Our ref: 107016

7 November 2020

SSD 7874 Redevelopment of the Harbourside Shopping Centre Submission on Visual Effects and Impacts of proposed further amended application

Figure 1
Principle for more appropriate view sharing
(Adapted from part of Page 3, FJMT Supplementary Architectural Design Report)

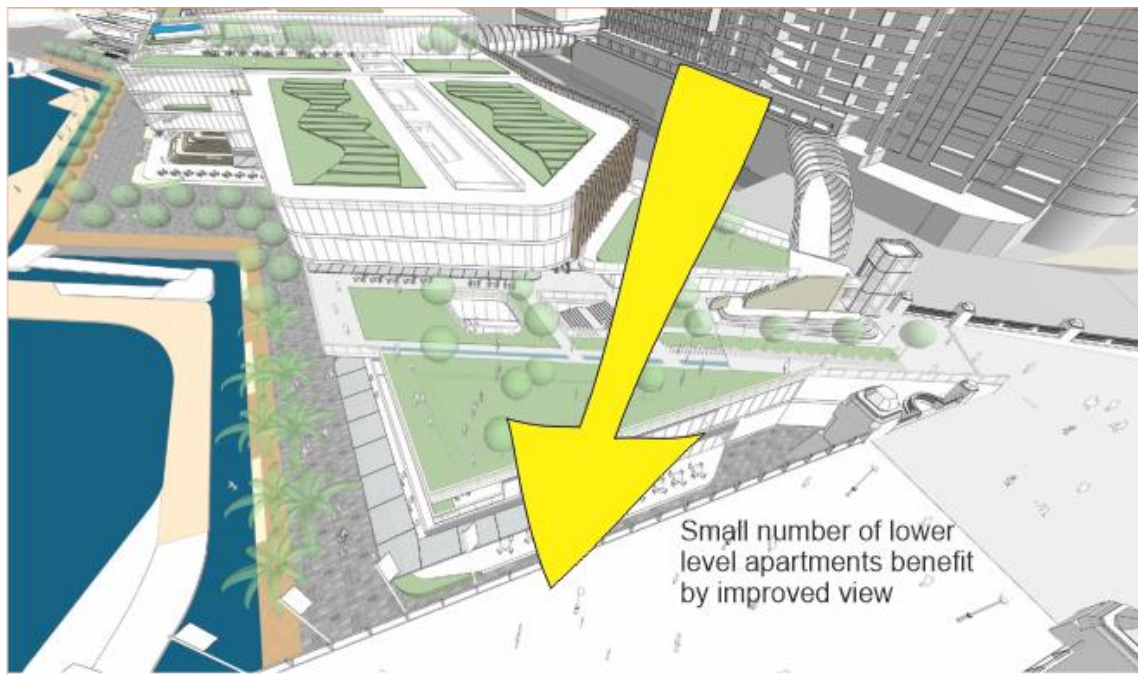
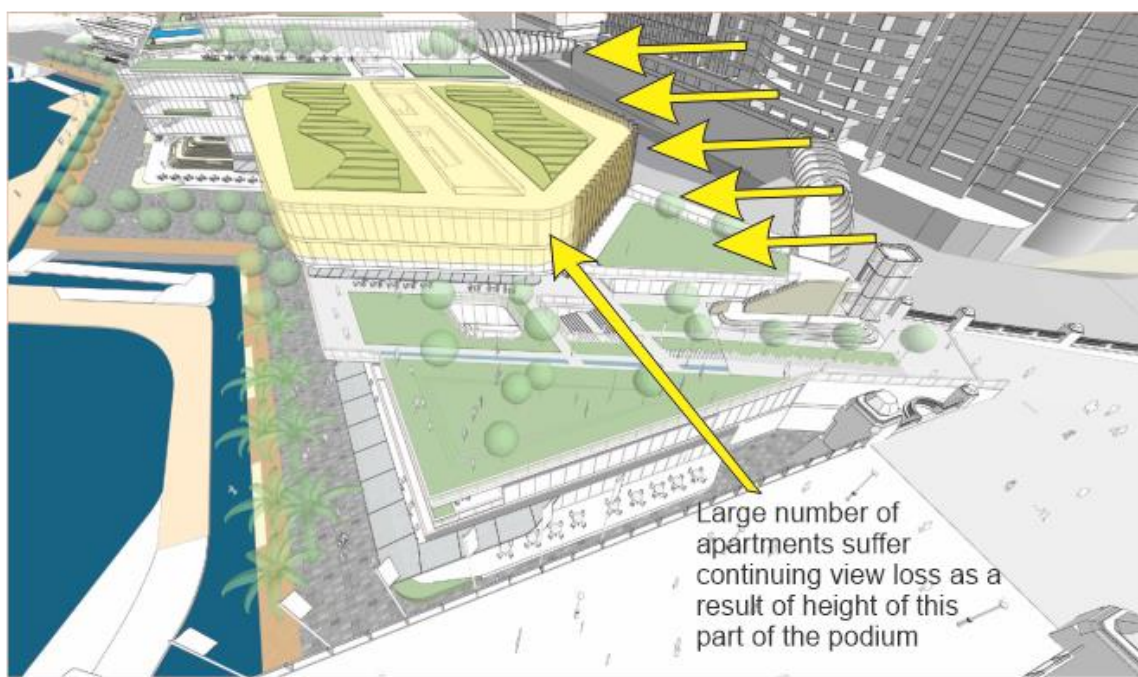
While a small number of apartments at the lowest levels would benefit in terms of view sharing, a larger number at many more levels above would suffer view loss in excess of the effects of the existing shopping centre. I have attached a markup on Image 31 of the Supplementary Design Report that demonstrates the part of the northern podium that continues to cause excessive impacts on view sharing. A more reasonable design would reduce the height of this part of the podium further to produce satisfactory view sharing with One Darling Harbour.

I have noted the part of the podium that is still of concern with regard to view sharing with One Darling Harbour on Figure 1 below, by means of a transparent yellow fill on a graphic adapted from Image 31 from the FJMT Supplementary Architectural Design Report. The slot in the podium benefits a small number of apartments, whereas the height of the part of the podium shaded yellow causes continuing unreasonable view loss for a much larger number. Reconsideration of the height of this part of the podium could provide a satisfactory outcome for One Darling Harbour in terms of view sharing.

The lower podium is an improvement to views from One Darling Harbour that is appreciated, but the benefit should be extended by moving the south boundary of the lowered section of the podium further south and on an alignment more directly easterly, for example to the alignment of the next step in height in the podium that is proposed further to the south.

If it is true that the cut out in the northern part of the podium is really intended to foster better view sharing, there is clearly the potential to extend that means of achieving this by cutting the northern extent of the main northern section of the podium further back. There was no loss of GFA involved in making the concessions associated with the Guardian Square podium, so there would seem to be none involved in cutting the height and bulk of the podium back further, to achieve a more equitable view sharing outcome.
